Service Letter No. 370

SUBJECT: Modification to Engine Breather Line

MODELS AFFECTED: PA-24 and PA-24 "250" Comanches - Serial Numbers 24-2175, 24-2299 to 24-2675 incl., 24-2677 to 24-2801 incl., 24-2803, 24-2804, 24-2806, 24-2808 to 24-2888 incl., 24-2890 to 24-2935 incl., 24-2937, 24-2939 to 24-2943 incl., 24-2945 to 24-2948 incl., 24-2950 to 24-2956 incl., 24-2958 to 24-2966 incl., 24-2969 to 24-2982 incl., 24-2984, 24-2986 to 24-2989 incl., 24-2991, 24-2992, 24-2994 to 24-3005 incl., 24-3007 to 24-3009 incl., 24-3011, 24-3012, 24-3014, 24-3016, 24-3018, 24-3020 to 24-3023 incl., 24-3027 to 24-3040 incl., 24-3042, 24-3043, 24-3046 to 24-3049 incl., 24-3052, 24-3055, 24-3059, 24-3060, 24-3062, 24-3068.

# SERVICE LETTER NO 370

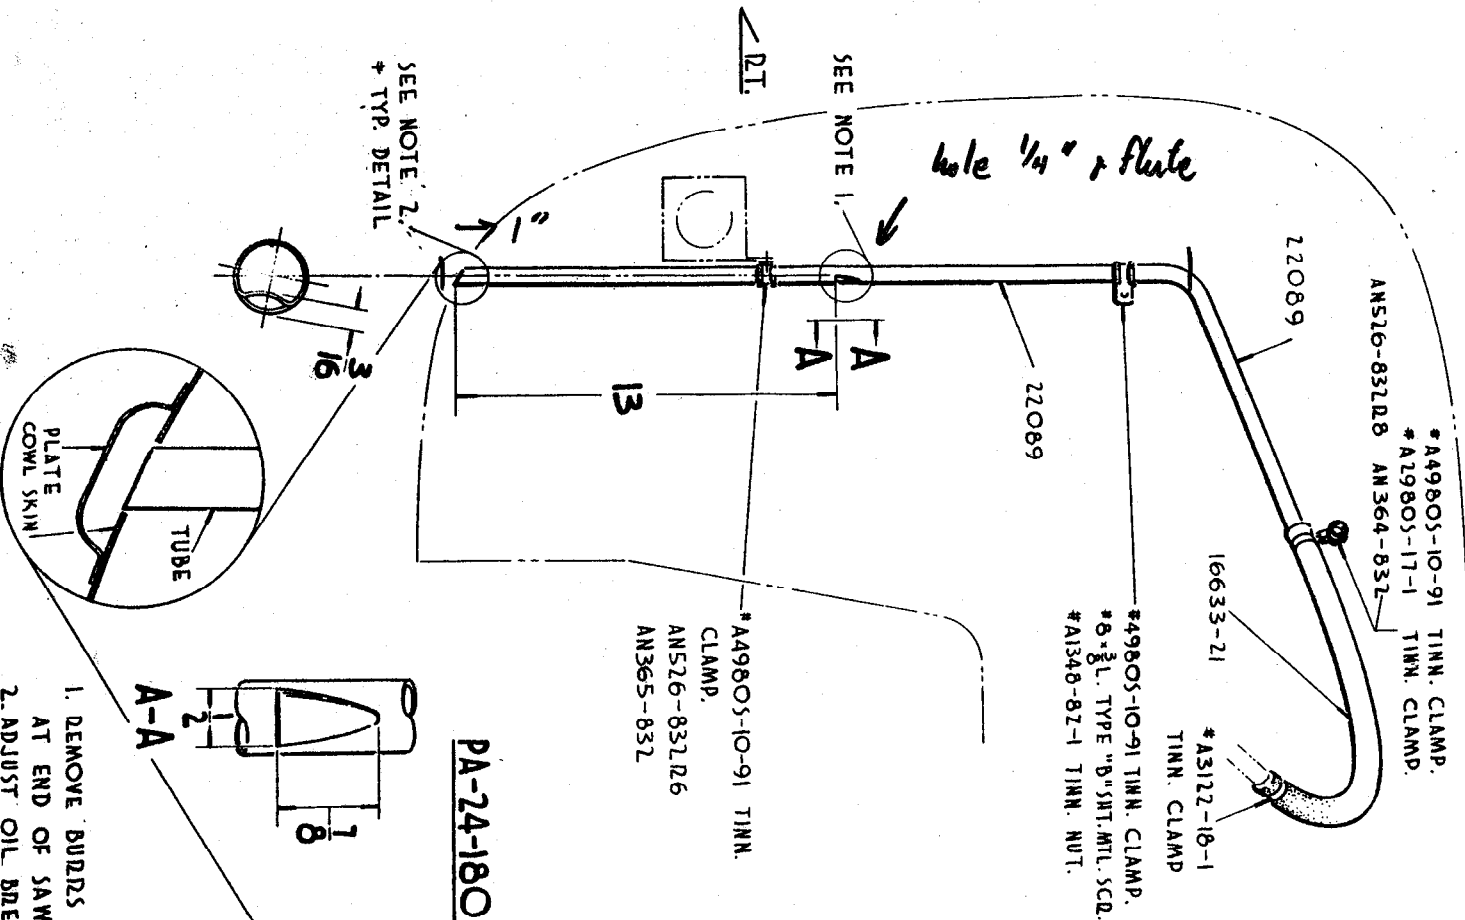
A few reports have been filed with the Service Department indicating that the engine breather line on the subject aircraft may extend below the opening in the bottom cowl.

The engine breather line should be inspected and, if necessary, adjusted so that it is flush with the bottom cowl. Refer to sketch on the reverse side of this Service Letter. The adjustment of this breather line, flush with the bottom cowl, will prevent the accumulation of ice at the opening of the engine breather line and in the scoop into which it vents.

As a precautionary measure, for operations in extensive icing conditions it is recommended that the engine breather line be modified to provide an alternate vent. This modification consists of a saw-cut across the engine breather line and forming the area above the saw-cut as shown in the sketch on the reverse side of this Service Letter.

NOTE: CARE SHOULD BE EXERCISED WHILE FORMING THE VENT  
SO THAT THE TUBE IS NOT FLATTENED OR DISTORTED.

1. REMOVE BURRS THAT MAY BE FORMED AT END OF SAW SLOT.
2. ADJUST OIL BREATHER TUBE FLUSH WITH SKIN.
